IEEE 802.3dg 100BASE-T1L: Downshift: Response to “Downshift State Diagram Issues” contribution from George Zimmerman

Peter Jones – Cisco
1/20/2026 5:00 PM

D3.0 issues identified

Figure 98D-1—Downshift state diagram

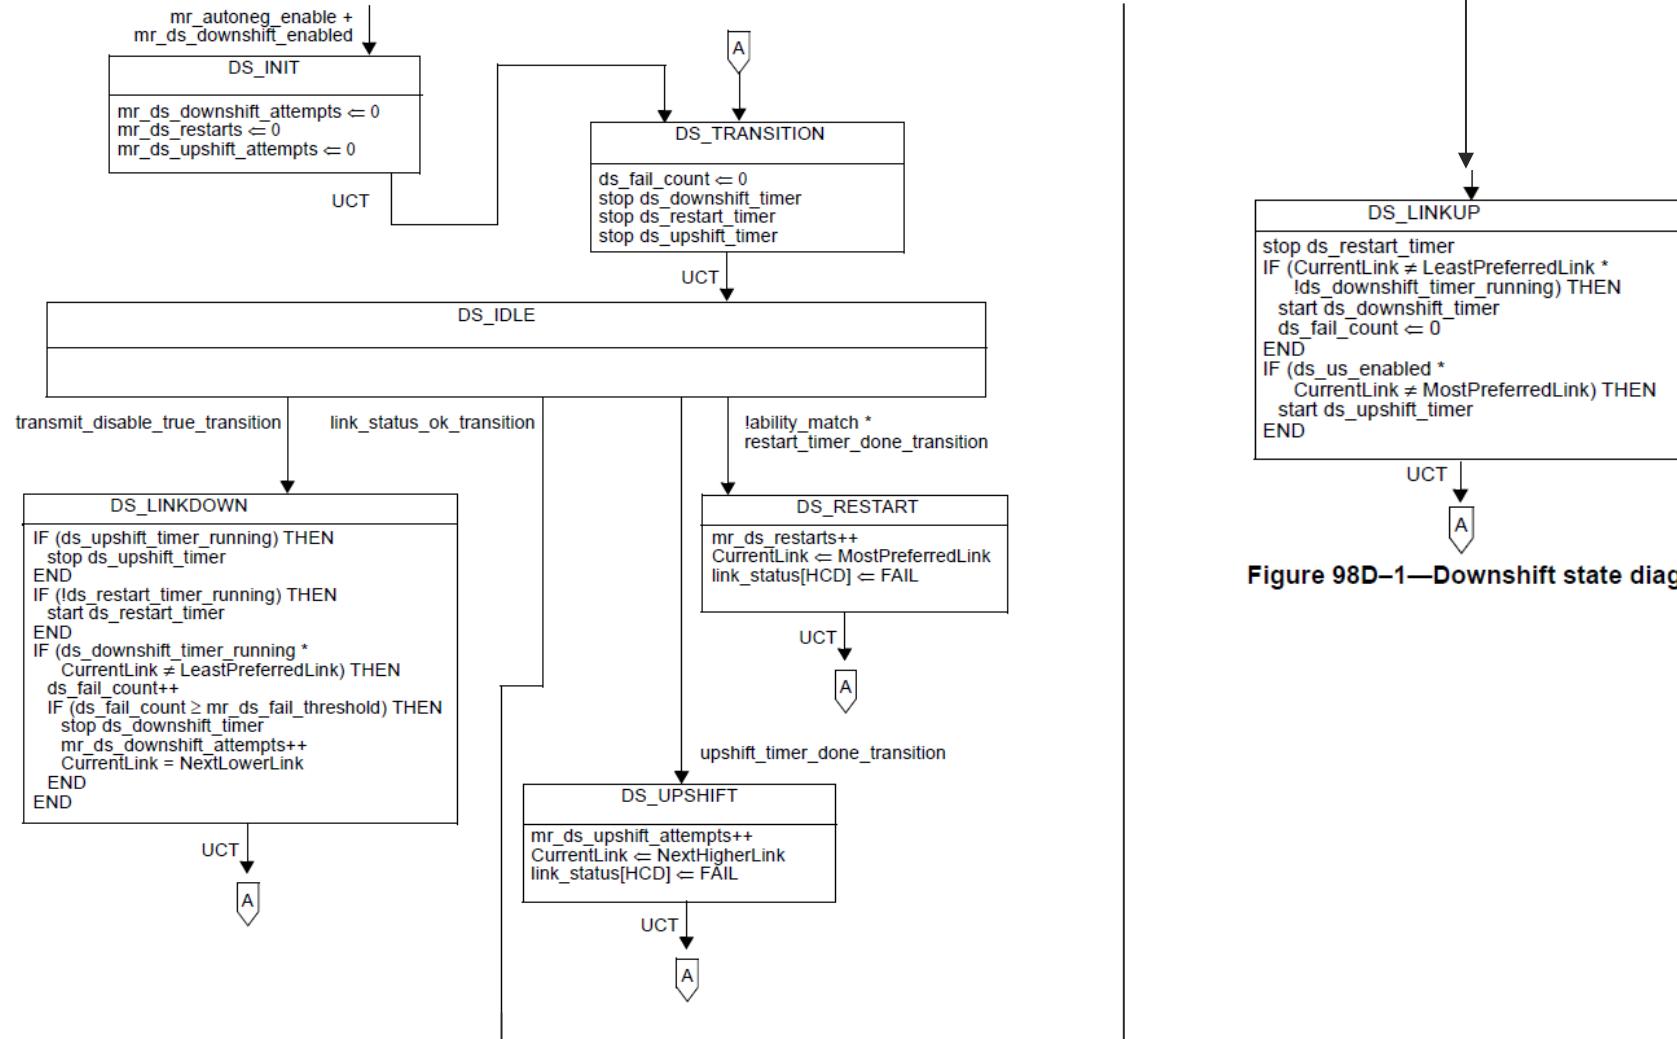
- https://www.ieee802.org/3/dg/public/May 2025/zimmerman_3dg_01_012026.pdf identifies several issues in the state diagram including:
 1. Stuck in DS_INIT state
 - Open ended transition into DS_INIT on mr_autoneg_enable & mr_ds_downshift_enabled
 2. Can never go to DS_UPSHIFT
 - upshift_timer is stopped before waiting for a transition...
 3. Can never go to DS_RESTART
 - restart_timer is stopped before waiting for a transition...
 4. ds_downshift_timer doesn't work – stopped right after started
 - ds_downshift_timer_done is never tested, perhaps "_running" might be a function of !done.

Item 1 - Stuck in DS_INIT state

- I agree. I did not remember (or never knew) the special rule for global transitions (21.5.3):

Any open arrow (an arrow with no source block) represents a global transition. Global transitions are evaluated continuously whenever any state is evaluating its exit conditions. When a global transition becomes true, it supersedes all other transitions, including UCT, returning control to the block pointed to by the open arrow.
- This clearly needs to be fixed.

Items 2, 3, 4 - timers

- I agree.
- I believe the changes are relatively simple, BUT, they need to be validated before we are done.
- We either fix this or pull it out.
- The next slide is an updated state diagram that I believe resolves the items 1-4 and cleans up other sundry issues.
- Decoder
 - additions in *bold italic*,
 - deletions in ~~strikethrough~~
 - commentary in **red-dashed -----**
